La Vista City Centre

CITY OF LA VISTA
PLANNING DIVISION

RECOMMENDATION REPORT

CASE NUMBER: 2016-SUB-04

SHEET
C3.2

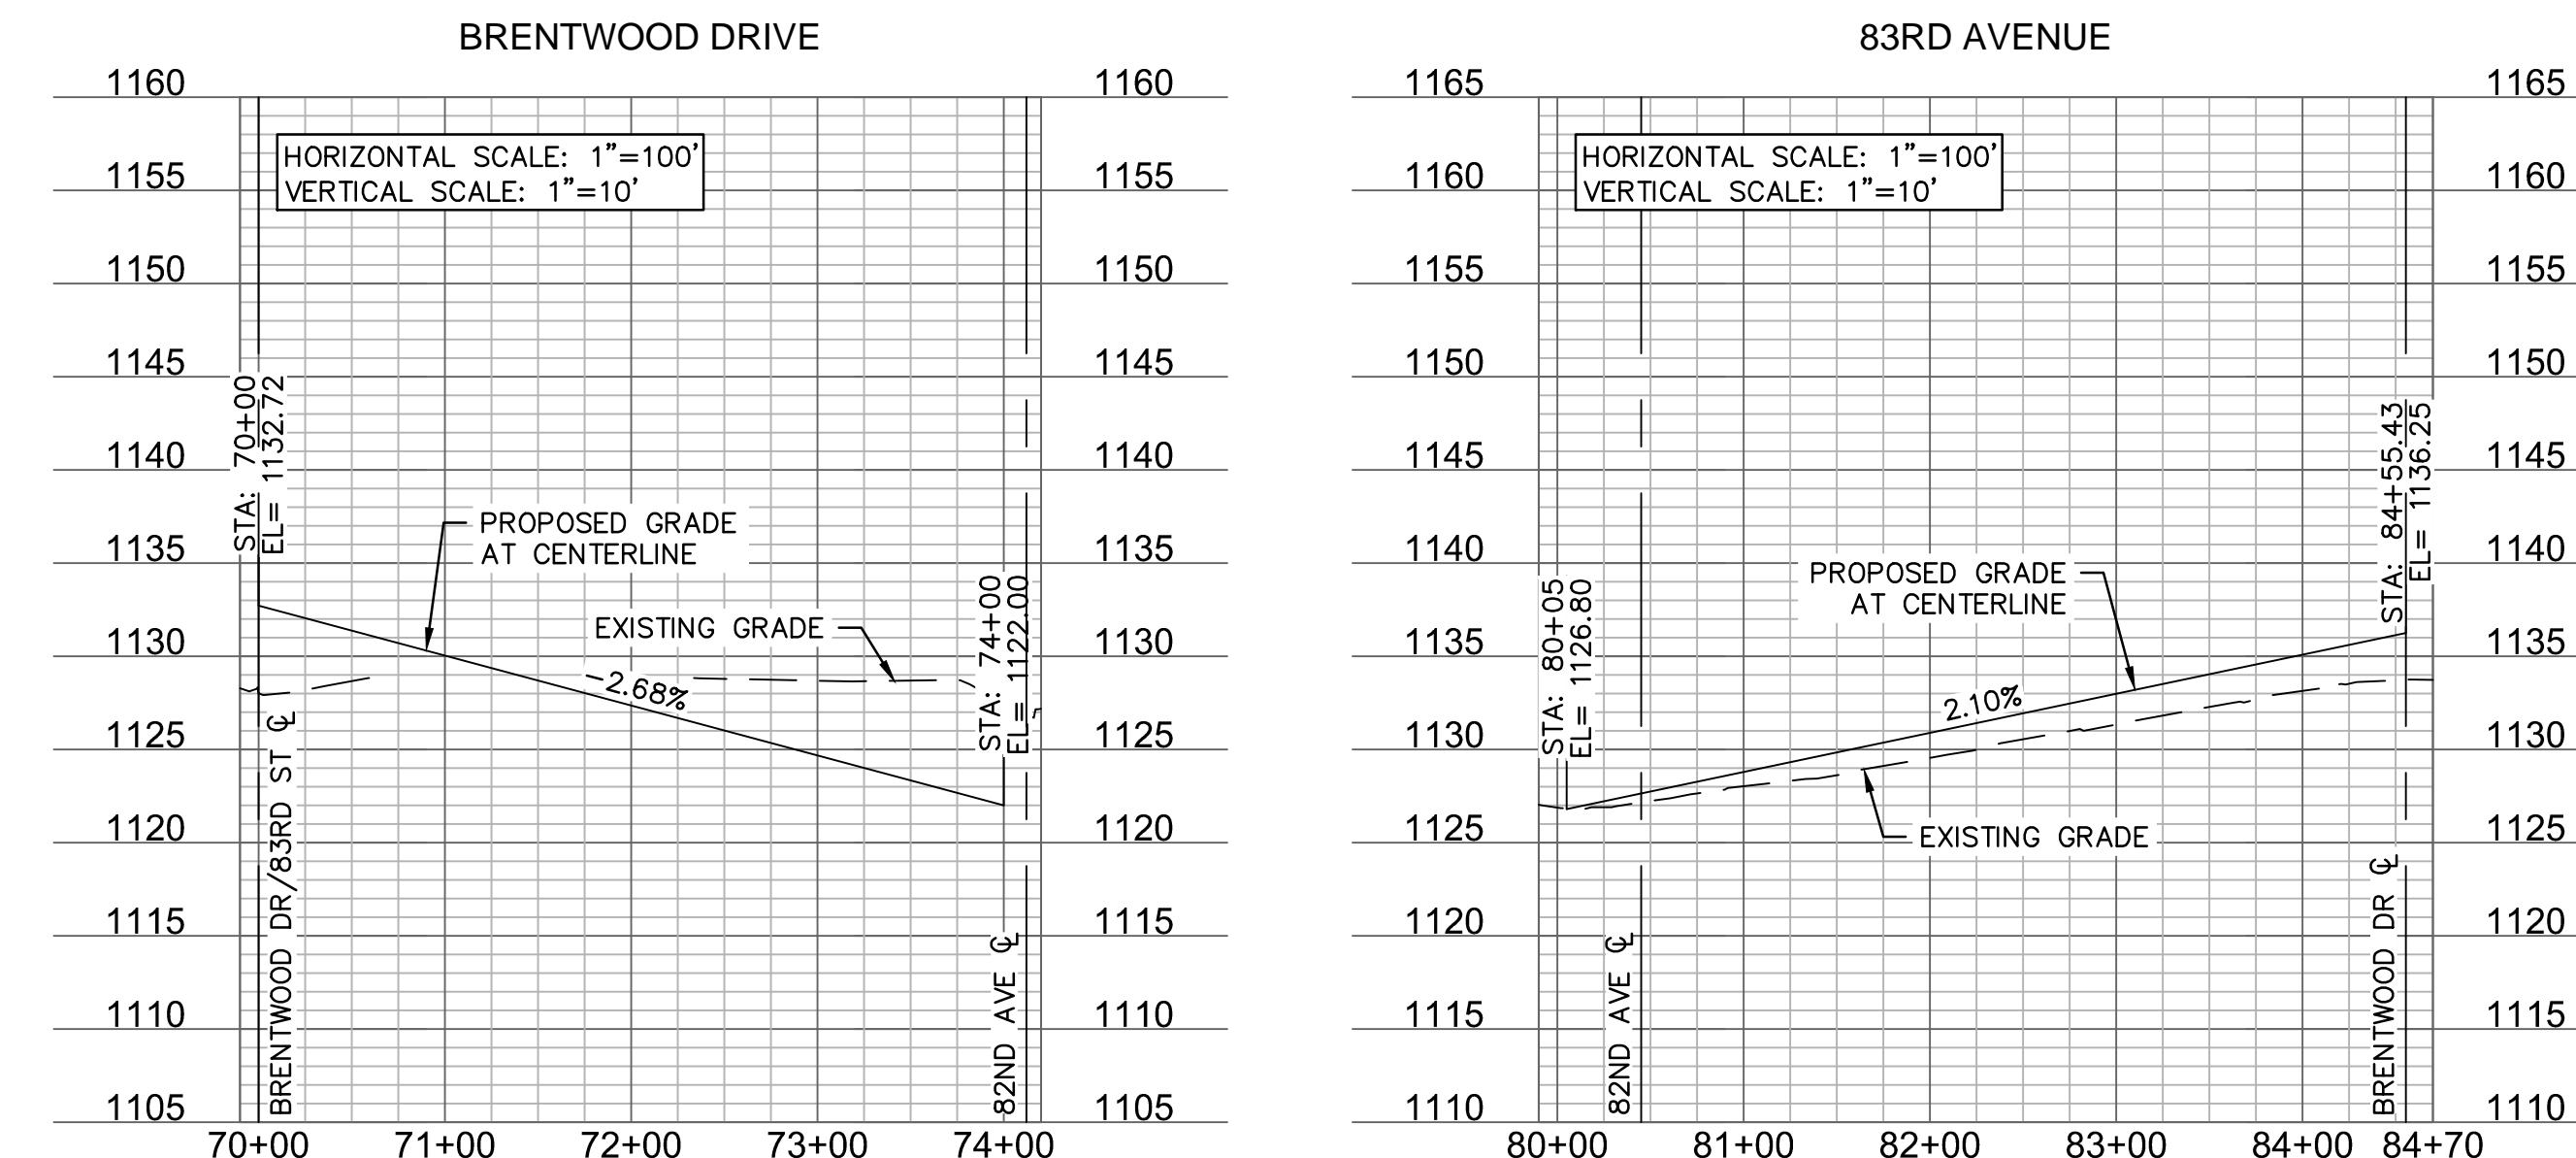
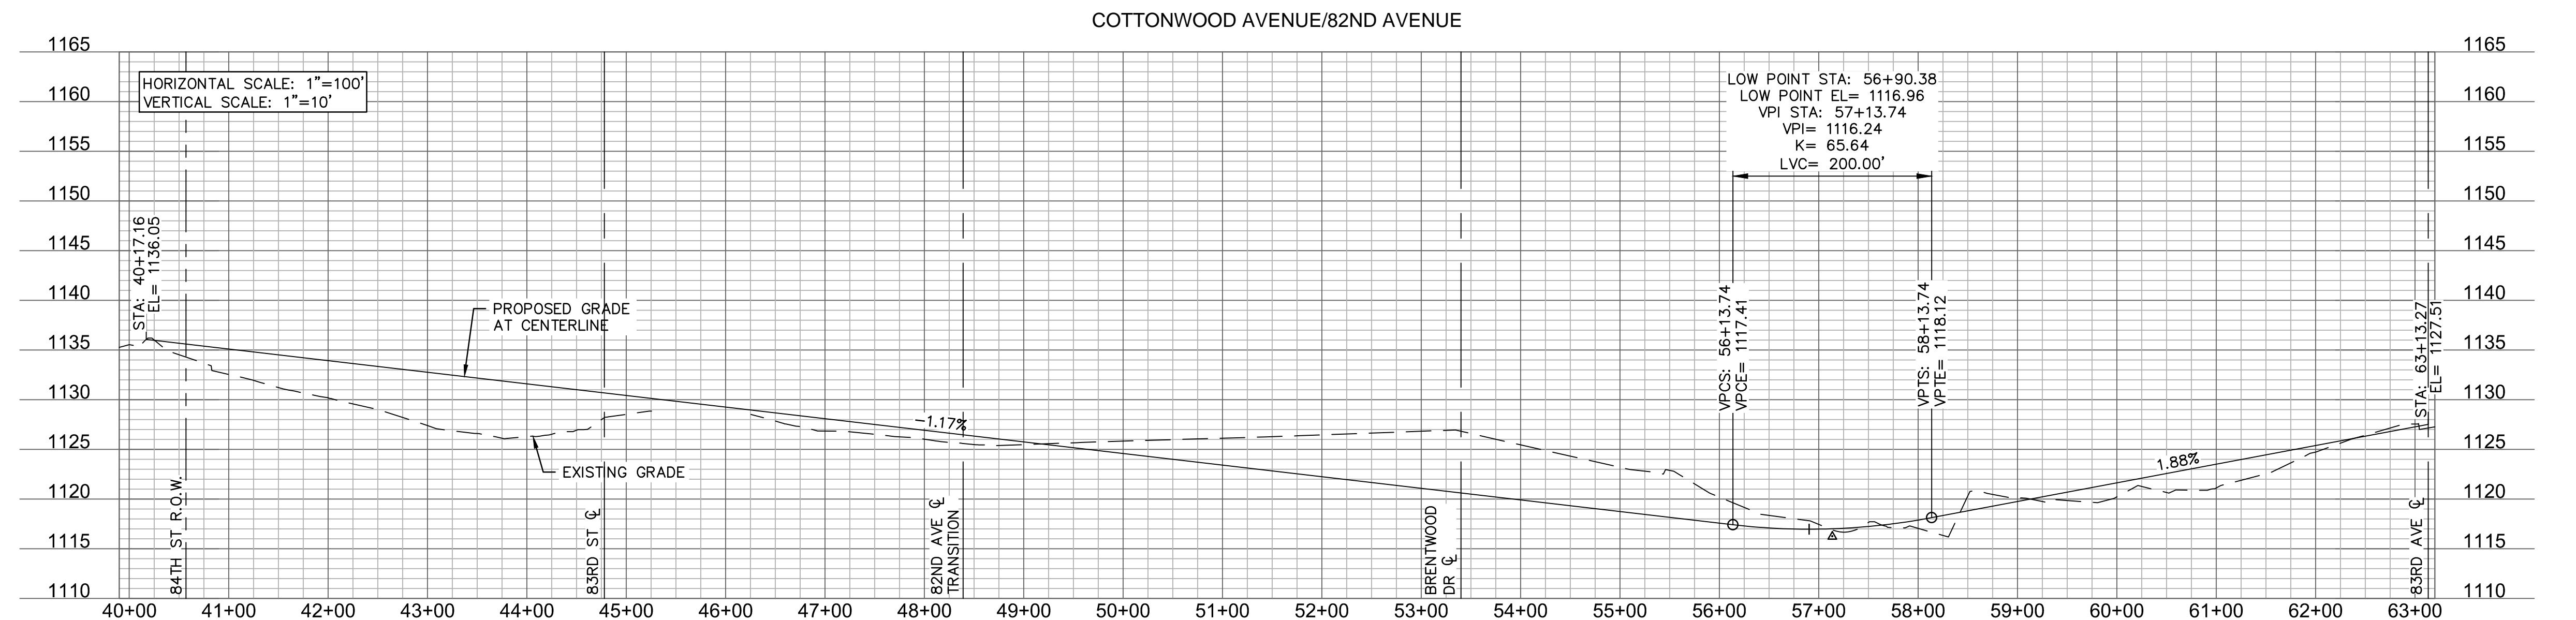
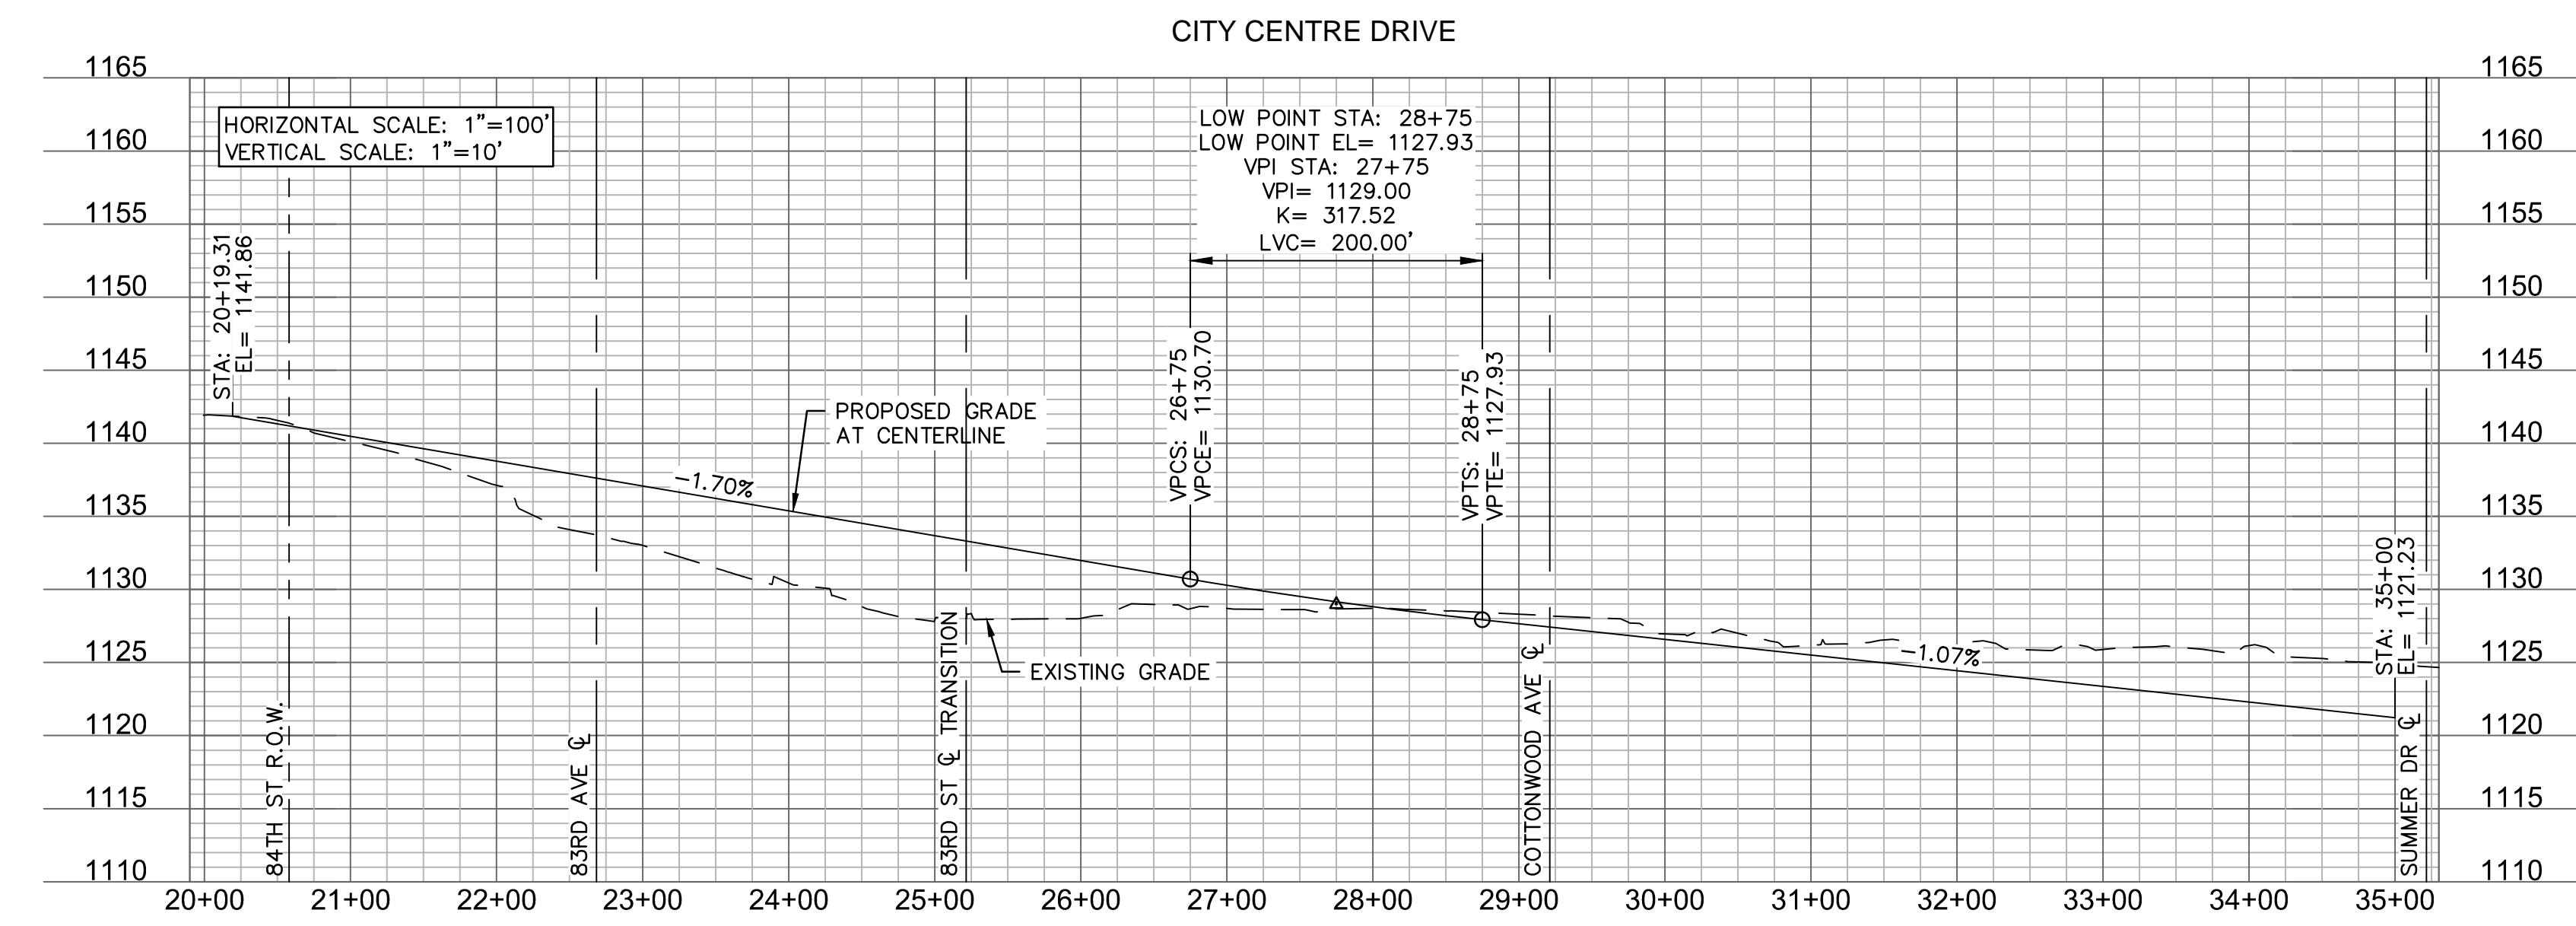
2. On Sheet C3.2 there needs to be a note added stating that a single grading and erosion control permit will be obtained for all lots in the preliminary plat. The fewest number of grading permits is preferred to allow for ease of administration and coordination of inspections as well as reducing permit costs for the applicant.

Response: Note has been added to the plan
